SUBJECT: ADDENDUM TO ORNL CF-61-2-46,  
MOLTEN-SALT REACTOR EXPERIMENT  
PRELIMINARY HAZARDS REPORT

ADDENDUM TO ORNL CF-61-2-46,  
MOLTEN-SALT REACTOR EXPERIMENT PRELIMINARY HAZARDS REPORT

Since the "MSRE Preliminary Hazards Report" was written (February 1961), several changes have been made in the MSRE design, and additional information has been requested by the AEC Division of Reactor Development. It is the purpose of this Addendum to up-date and correct the original report and to provide the additional information.

Fig. 4(Rev.). Typical Graphite Stringer Arrangement.

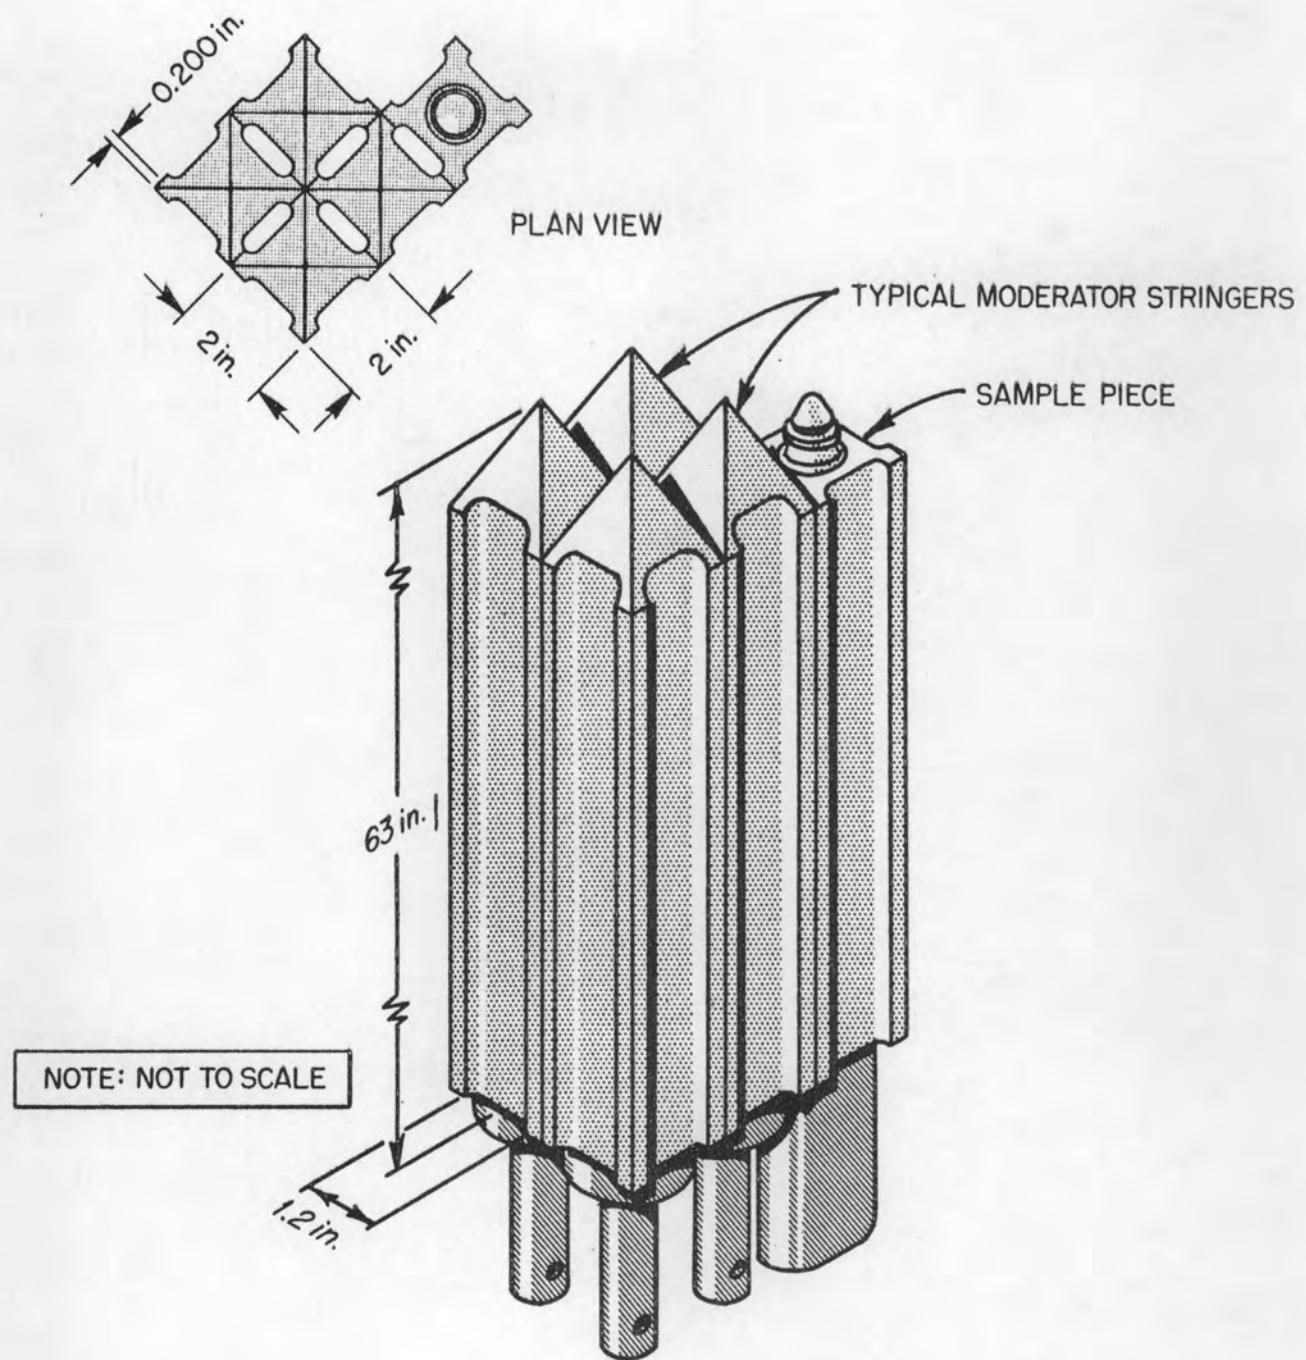
An access port of 10-in. diameter replaces the fuel outlet shown in Fig. 3. The new outlet is a branch off this port. A hollow plug fits into the port, serving as support for control-rod thimbles and graphite-sampling devices. The core graphite configuration was slightly altered, as shown on the new Fig. 4. The top core shield has been removed. Its original purpose was to provide shielding between the reactor and the pump. A revised table of Design Data is included as Table 4.

Fig. 7(Rev.). MSRE Radiator Coil and Enclosure.

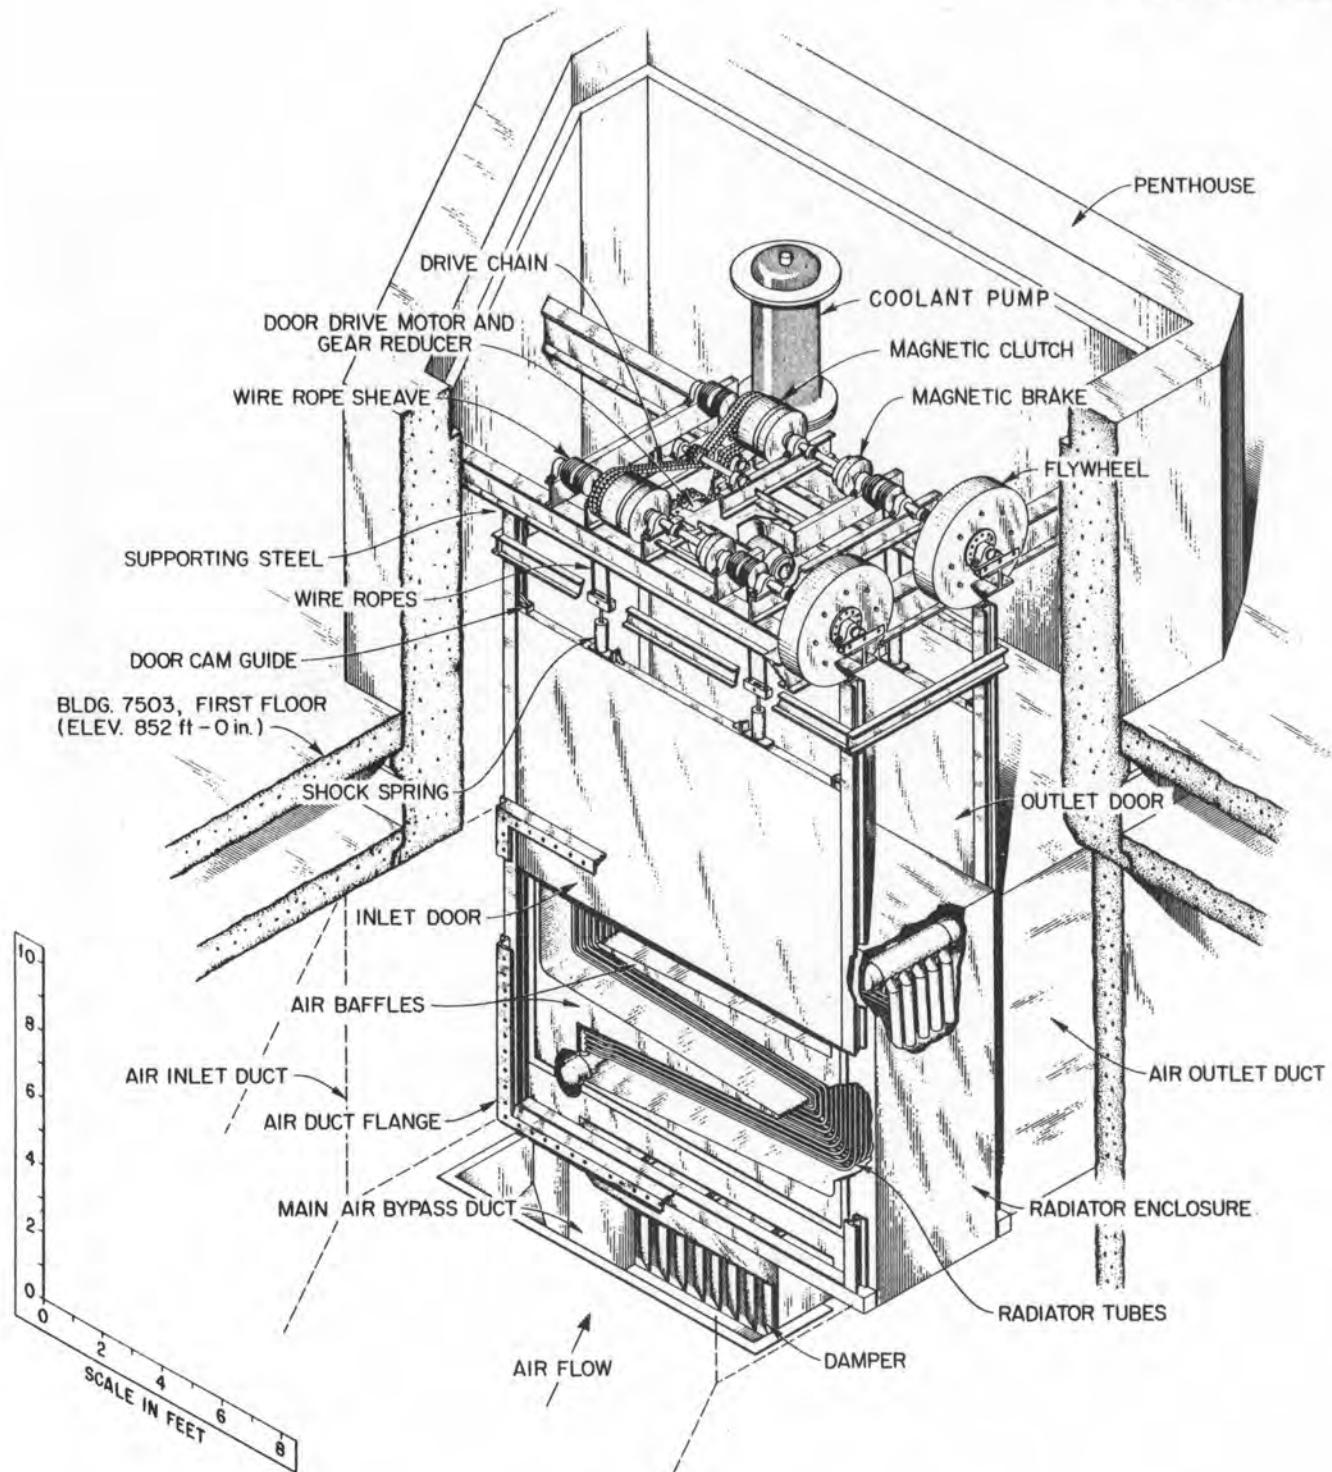
Although the radiator design has not changed, the enclosure has been modified to provide more protection against freezing of coolant salt in the radiator. The two sliding doors on the radiator enclosure now operate individually; thus cooling will be drastically reduced by closure of either one of the two doors. The heat losses with one door up is only 130 kw when the fans are off. Furthermore, the closing time of the doors has been reduced to less than 10 seconds. A revision of Fig. 7 is attached, along with revisions of Table 7.

Fig. 9(Rev.). Cooling Thimble for Fuel-Salt Drain Tanks.

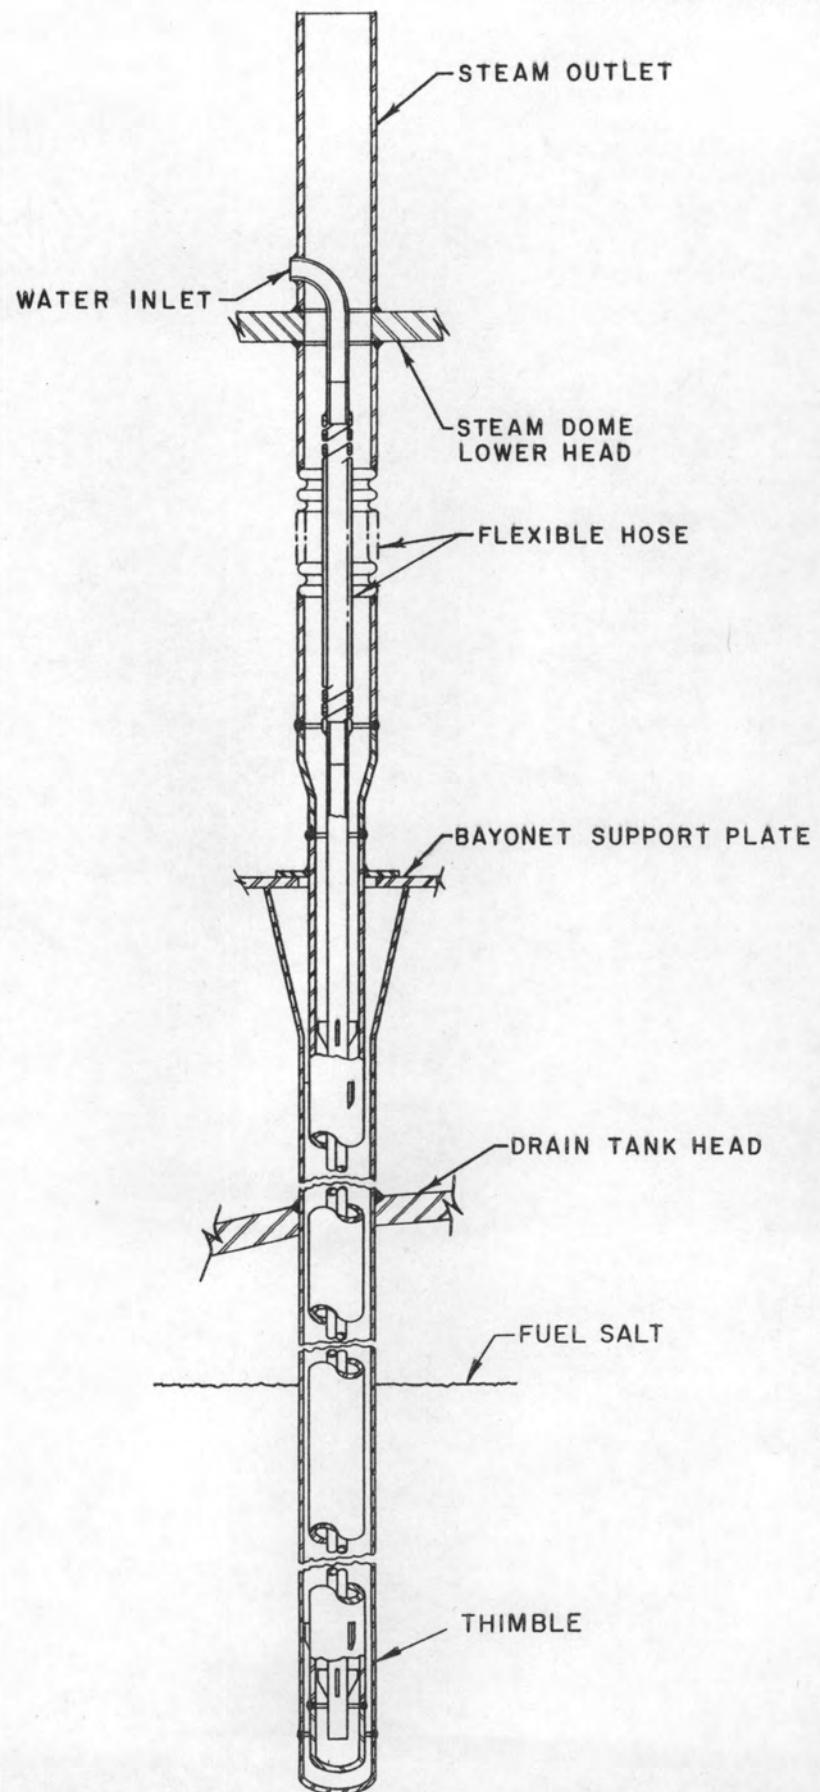
A revised Design Data Sheet and a revision to the Coolant Thimble Drawing (Fig. 9 R) are presented.

The cooling system for the drain-tank thimbles has also been slightly modified. Previously, in an emergency, it was planned to cool by evaporating a small emergency reservoir and venting the steam to the stack. In case fission-product activity was present in the normally-closed convection cooling system, it would have been also vented to the stack.

In the revised cooling system the condensate-filled closed loop is kept closed, and a much larger reservoir has been provided on the closed-cooling-loop condenser. So now in an emergency in which pump power is lost, the reservoir would drain by gravity through the cooling-system condenser, providing cooling for about 15 hours even if no additional water were added to the reservoir. If for some reason the reservoir fill line were not available after 15 hours, fire hoses could be run to provide cooling for an indefinite time.

Fig. 10A. Cover Gas System Instrument Application Diagram.

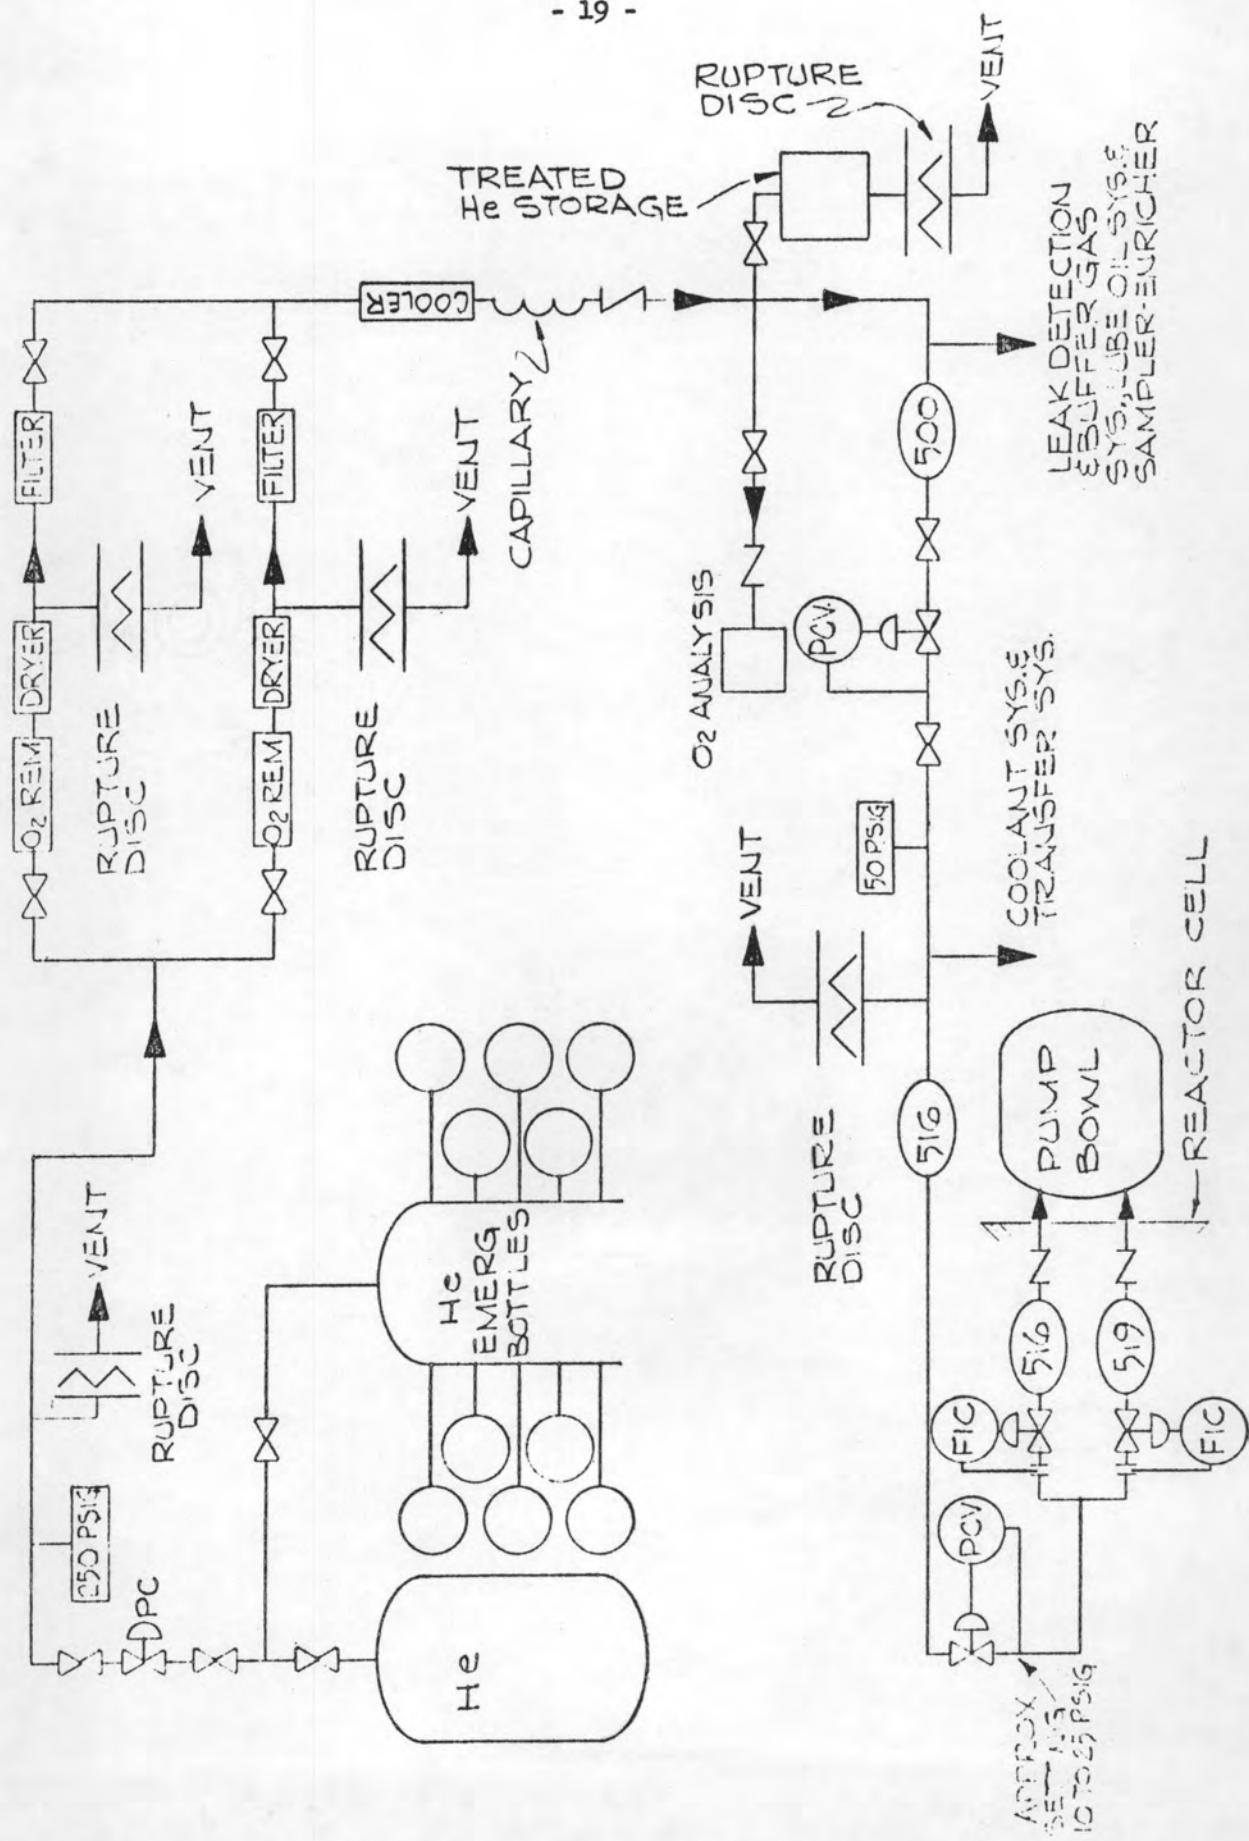
An instrument application diagram of the cover-gas system is presented in Fig. 10A. Rupture discs are provided at several stages of pressure reduction, so that the reactor piping is protected against pressures above 50 psig.

Fig. 14A. MSRE Control Rod Arrangement.

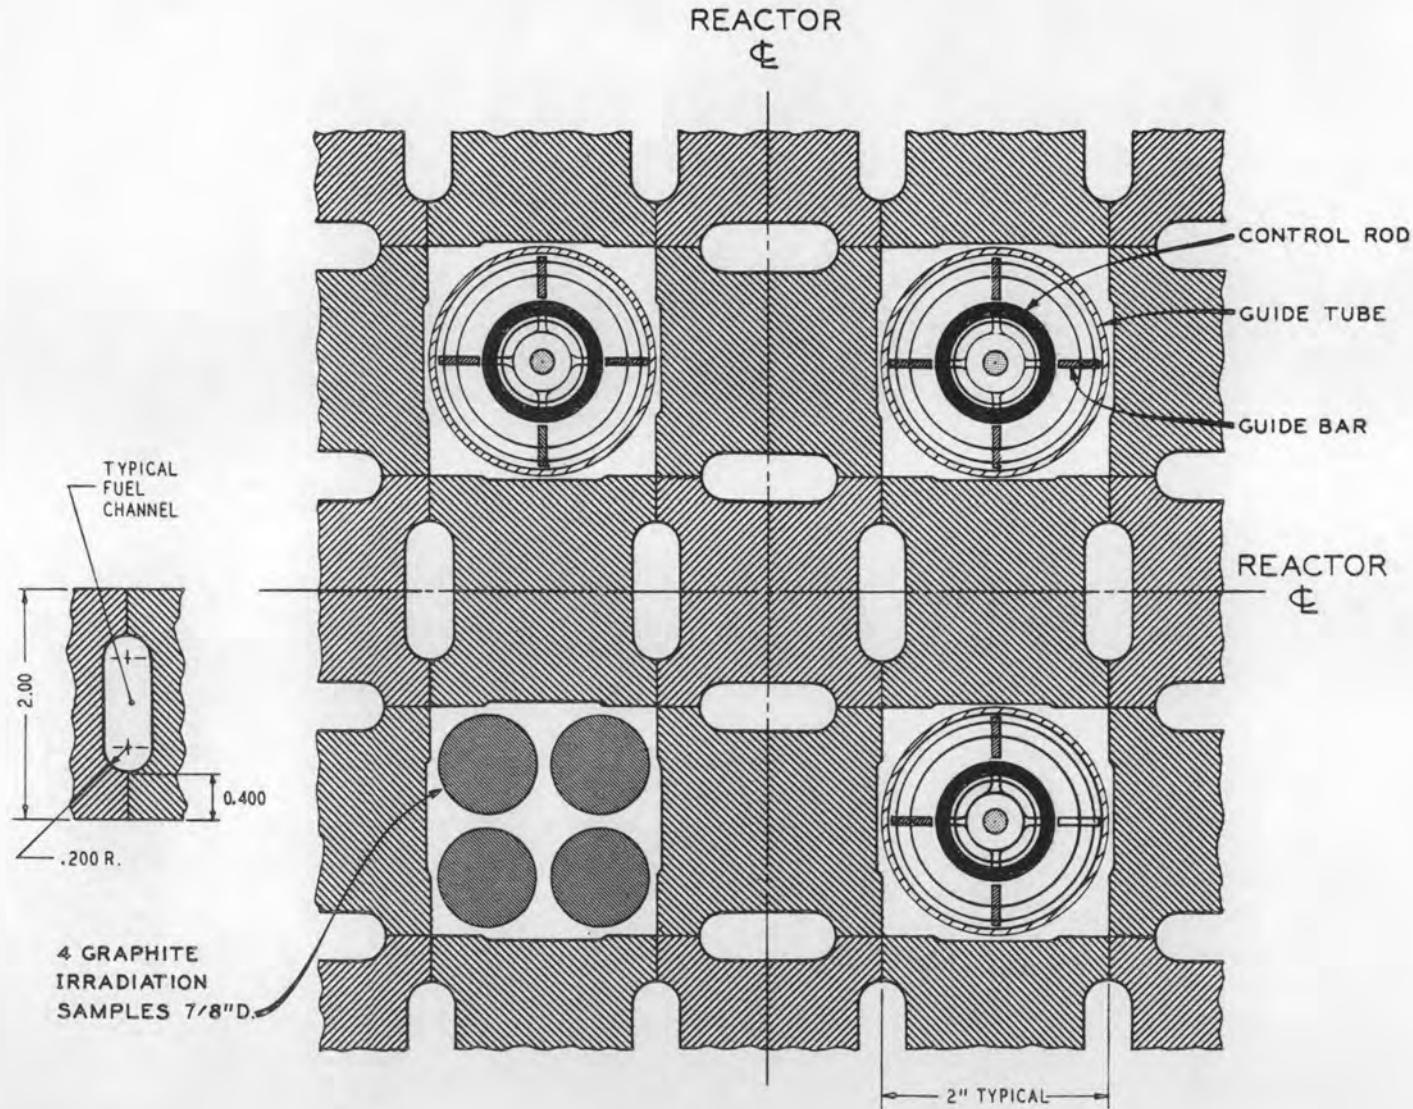
The rods are centrally located and move vertically. Figure 14-A is a horizontal section through the core showing rod locations and the location of the graphite irradiation samples.
